Economic Commission for Europe

Group of Experts on cycling infrastructure module

Cycling infrastructure definitions and standards

Considerations and proposals concerning cycle definition and provisions for markings and for traffic light signals from the 1968 Convention on Road Signs and Signals and related instruments

Figure 11. Another example with the arrows for cyclists indicating both straight and right.
Source: STANDARDY ROWEROWE DLA MIASTA POZNANIA, https://zdm.poznan.pl/upload/standardy_r.pdf

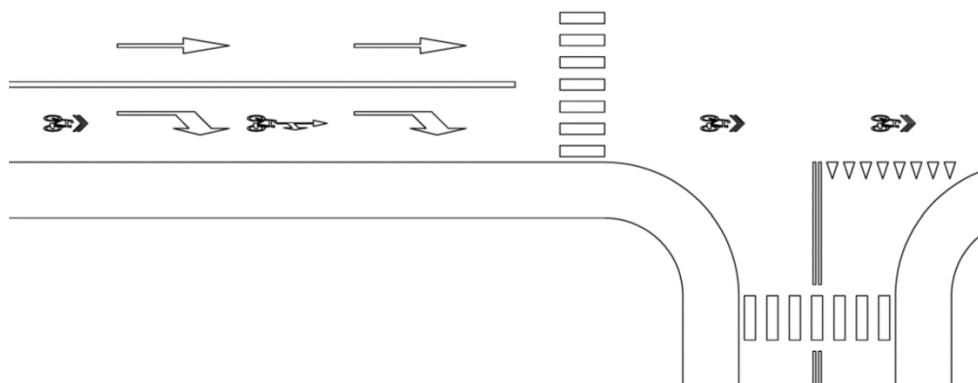
23. At the same time, it is recognized that the 1968 Convention does not currently include such a solution. It is therefore proposed to add a pre-selection sign as a variant of a E,4 sign depicting a possibility for a cycle to go straight from a lane indicating a right turn for general traffic.

24. This issue should be also addressed for road markings, covered in Annex 2, Chapter IV of the Convention. In this case, paragraph 39 under A. Arrow markings should read as follows:

25. A possible diagram depicting such a solution is provided in Figure 11.

*On roads having sufficient traffic lanes to separate vehicles approaching an intersection, the lanes to be used may be indicated by lane selection arrow markings on the surface of the carriageway (diagrams A-39 to A-41). Lane selection arrows may also be used on a one-way road to confirm the direction of traffic. The lane selection arrows should be not less than 2 m (6 ft. 7 in.) long. They may be supplemented by word markings on the carriageway. **The lane selection arrows supplemented by word markings or symbols of category of users may be used on the same lane as another lane selection arrow to indicate that the lane may be used by the category of users differently (diagram A-...)***

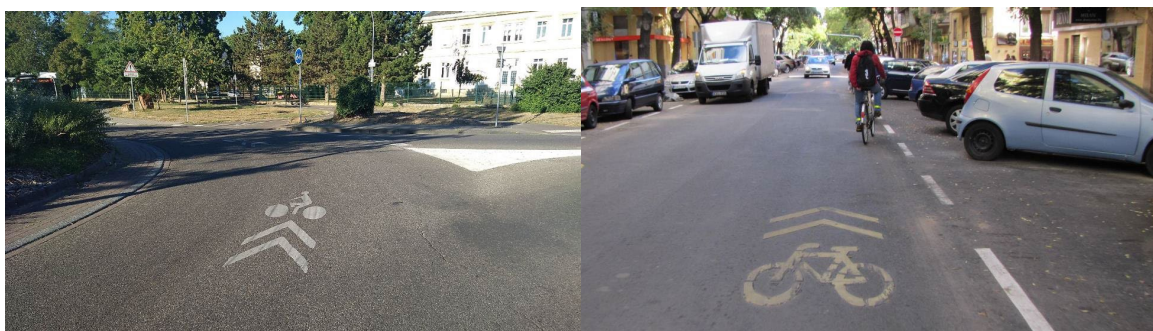
26. It is then noted that paragraph 39 refers to arrow markings which may be supplemented by word markings. In this case, it should be recognized that categories of users are often better (more readable, understandable for international road users) represented by symbols than word markings. For example, a symbol of a cycle used for arrows for cyclists, can be much more practical than word markings “DVIRATIS”, “FIETS” or “ROWER – see Figure 12. For this purpose, paragraph 13 could be further modified, as follows:

On roads having sufficient traffic lanes to separate vehicles approaching an intersection, the lanes to be used may be indicated by lane selection arrow markings on the surface of the carriageway (diagrams A-39 to A-41). Lane selection arrows may also be used on a one-way road to confirm the direction of traffic. The lane selection arrows should be not less than 2 m (6 ft. 7 in.) long. They may be supplemented by word markings or symbols of a category of users (for example, cycle) on the carriageway. The lane selection arrows supplemented by word markings or symbols of category of users may be used on the same lane as another lane selection arrow to indicate that the lane may be used by the category of users differently (diagram A-...)
